NORTH AMERICAN ELECTRIC
RELIABILITY CORPORATION

Re: Errata to Petition of the North American Electric Reliability Corporation for Approval of Proposed New Reliability Standards and Implementation Plans Related to Under-frequency Load-Shedding, *North American Electric Reliability Corporation* FERC Docket No. RM11-20-000

Exhibit A

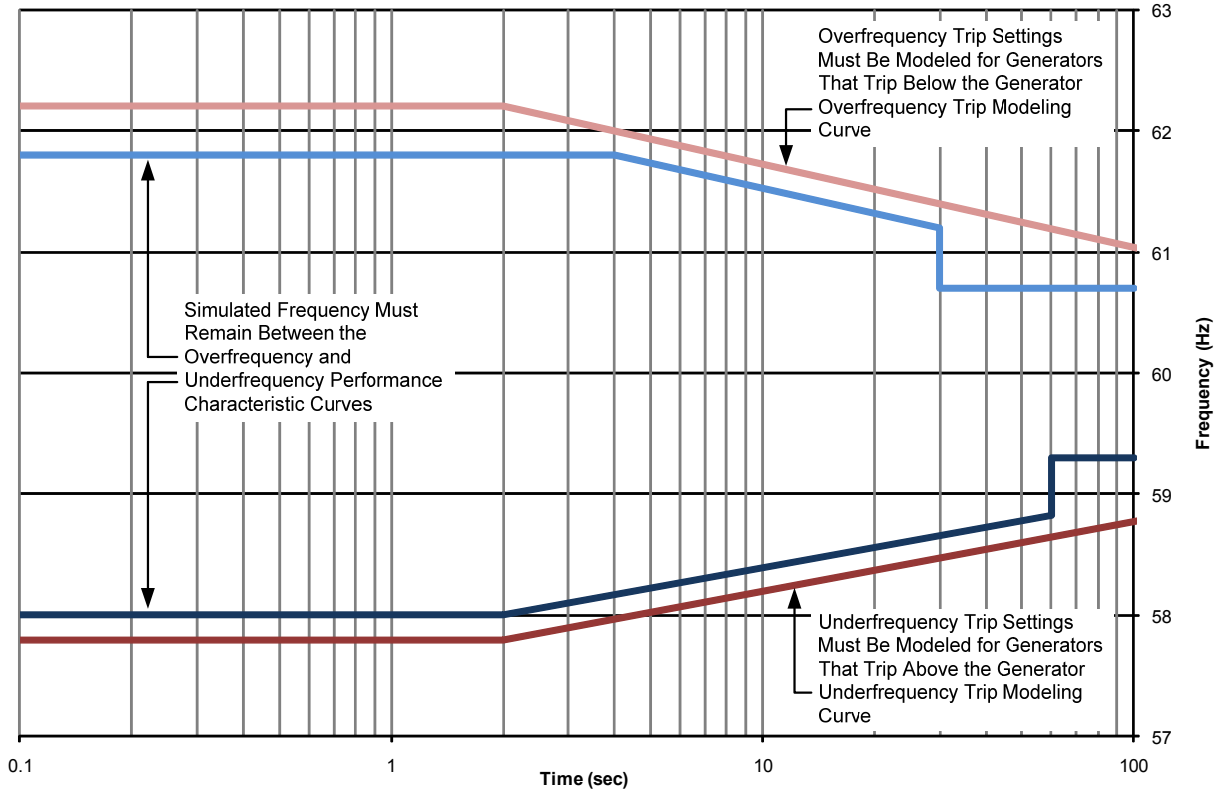
In the **Exhibit A** — Reliability Standards Proposed for Approval to this filing, the PRC-006-1 Reliability Standards included two graphs. The first graph (found on pg. 28 of the standard and pg. 117 of the filing) is the UFLS Program Design Performance and Modeling Curves for Requirements R3, Parts 3.1-3.2 and R4 Parts 4.1-4.6. In the process of conversion to pdf format, the labels on the right side and bottom axes, meant to be labeled frequency (hz) and the time (sec), were inadvertently omitted. NERC has included a corrected **Exhibit A** in this filing.
